STATE BUILDING CODE TECHNICAL REVIEW BOARD

Friday, May 21, 2021 - 10:00am (Virtual Meeting)

49
50 Appeal of Monica and Michael Davis; Appeal No. 20-03:
51
52 After review and consideration of the final order presented in the
53 Review Board members' agenda package, Mr. Payne moved to approve
54 the final order with the suggested editorial change to delete "d" for the
55 word "required", creating the word "require", in line 100 on page 37
56 and remove the word "do" and replace it with the word "may" in line
57 157 of page 43 of the agenda package. The motion was seconded by
58 Ms. Jackson and passed with Messrs. Pharr, Givens, Hutchins, and
59 Mays abstaining.

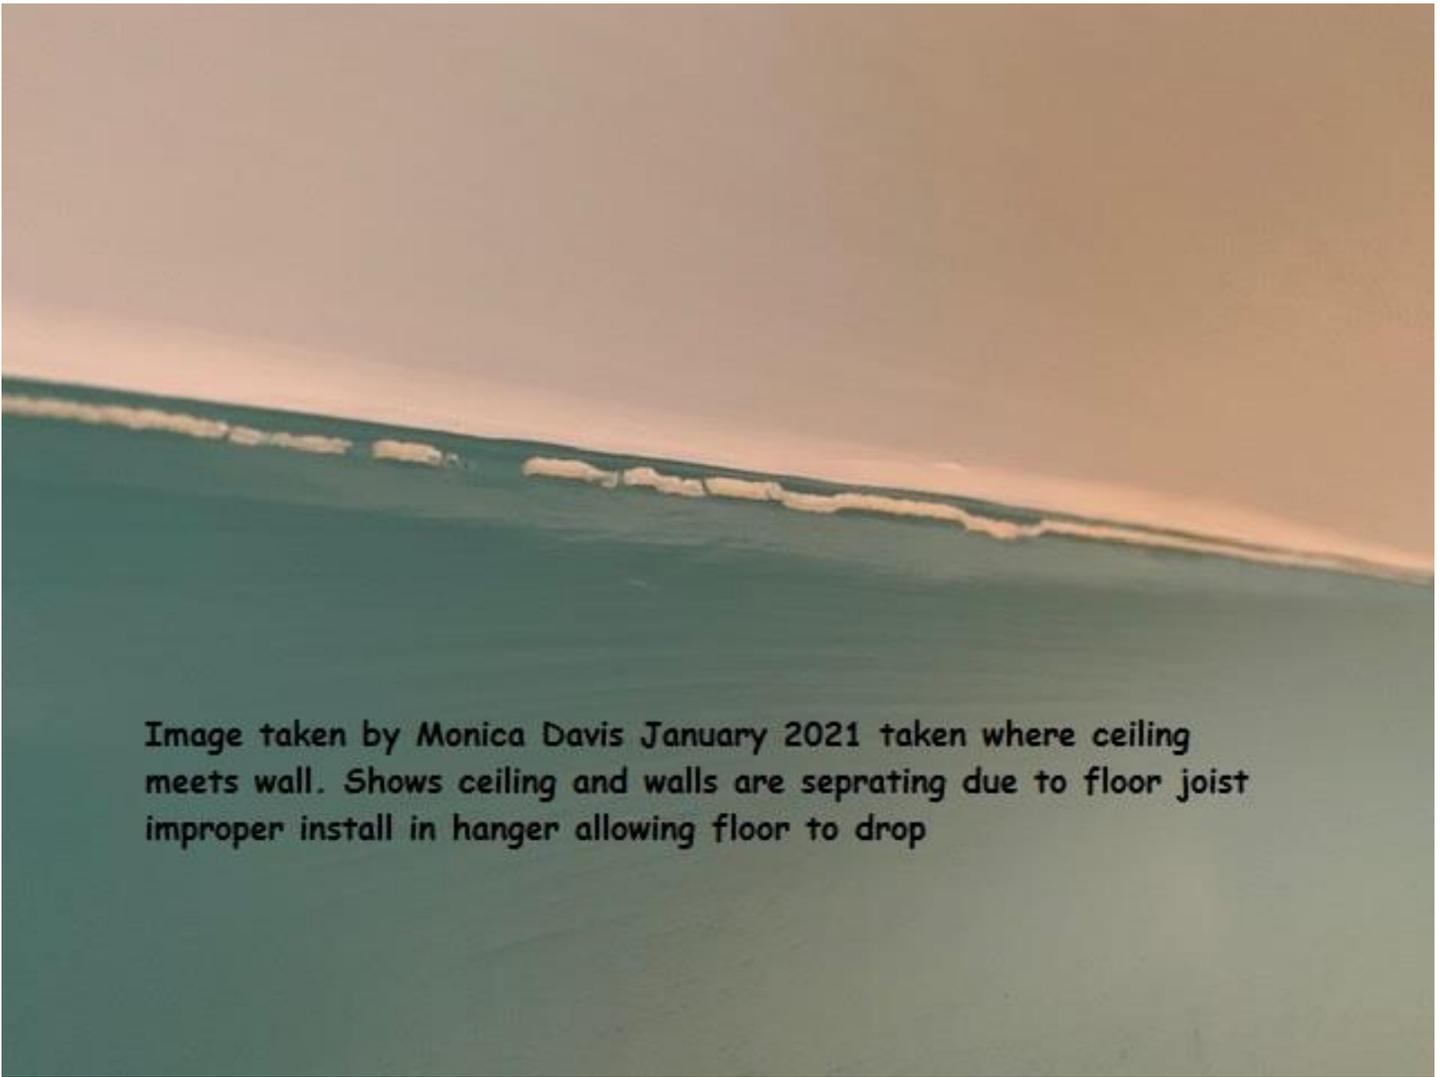
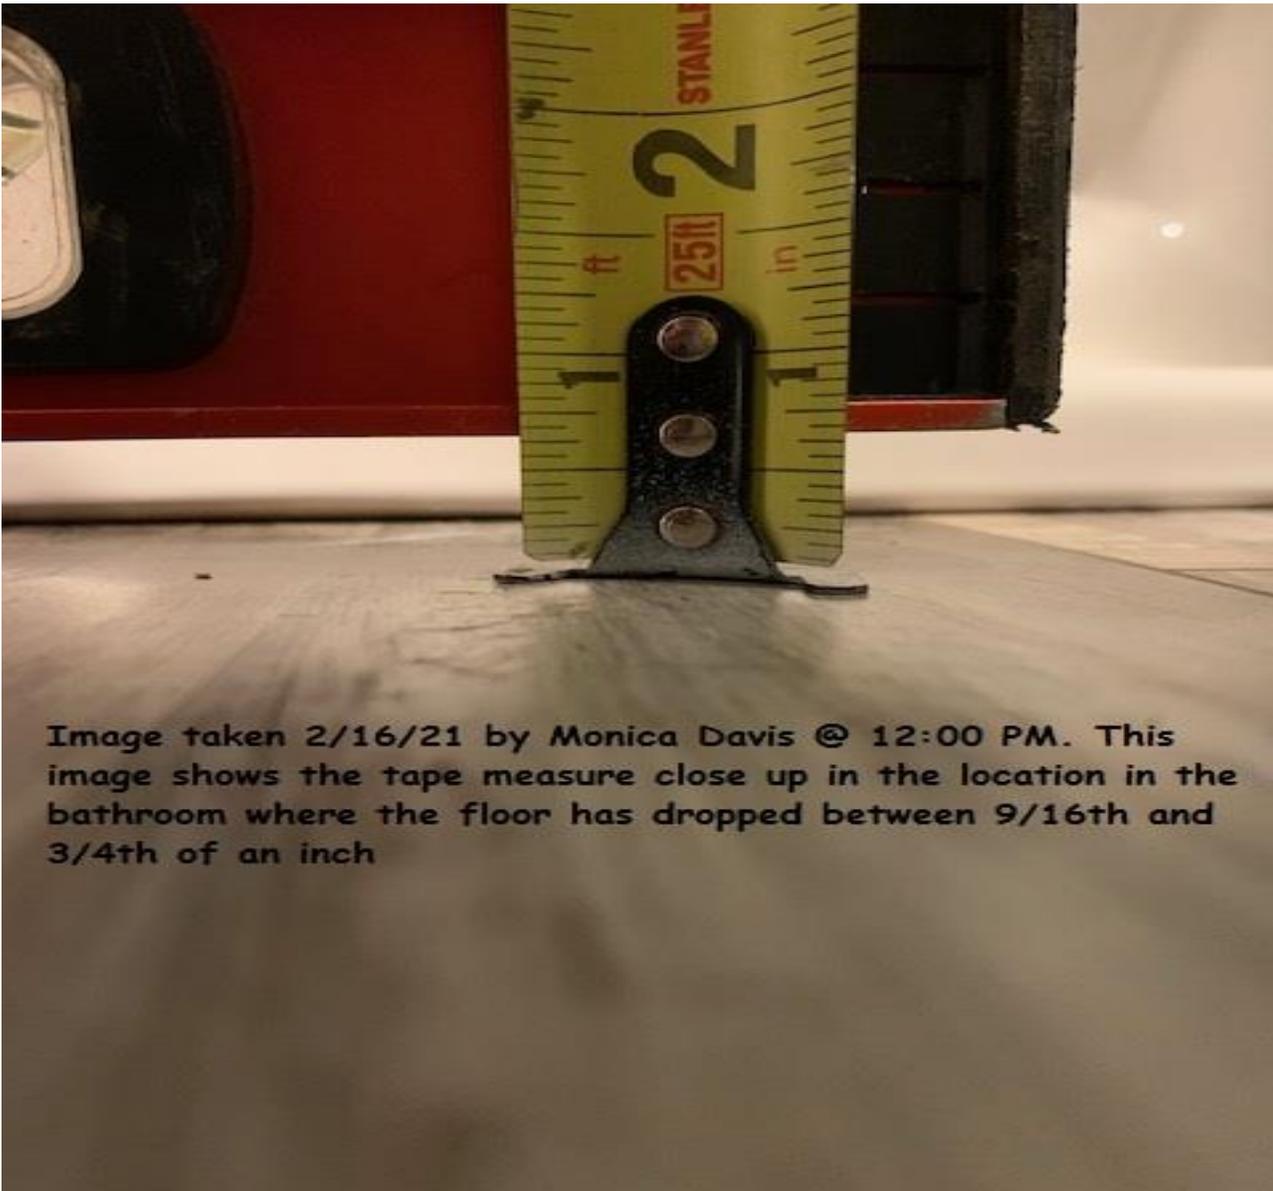
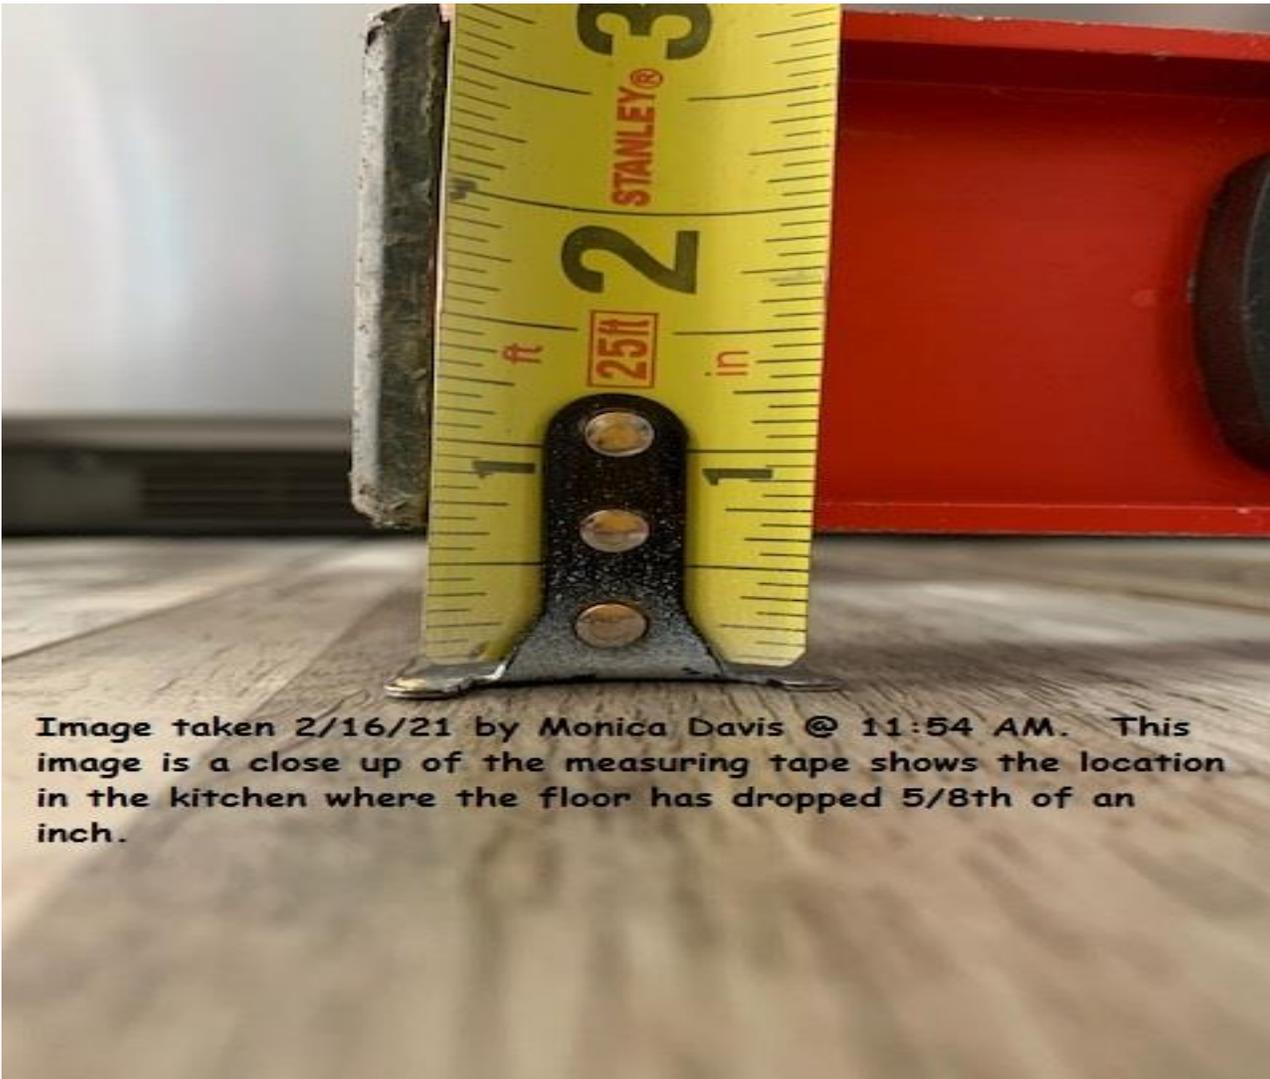
Image taken by Monica Davis January 2021 taken where ceiling meets wall. Shows ceiling and walls are seprating due to floor joist improper install in hanger allowing floor to drop

Image taken 2/16/21 by Monica Davis @ 12:00 PM. As indicated would happen by simpson literature due to the gape in the hangers and the improper hardware Joist with gap puts downward force further from header and creates more rotation. This image shows the location in the bathroom where the floor has dropped between 9/16th and 3/4th of an inch

Image taken 2/16/21 by Monica Davis @ 11:56 AM. As indicated would happen by simpson literature due to the gape in the hangers and the improper hardware Joist with gap puts downward force further from header and creates more rotation. This image shows the location in the living room where the floor has dropped 5/8th of an inch

Image taken 2/16/21 by Monica Davis @ 11:54 AM. As indicated would happen by simpson literature due to the gape in the hangers and the improper hardware Joist with gap puts downward force further from header and creates more rotation. This image shows the location in the kitchen where the floor has dropped $\frac{5}{8}$ th of an inch.

8. Floor joist are not all installed in the joist hangers to manufacturer's specifications. Need to correct to manufacturer's requirements or provide engineers design and approval in accordance with section R301.1.3.
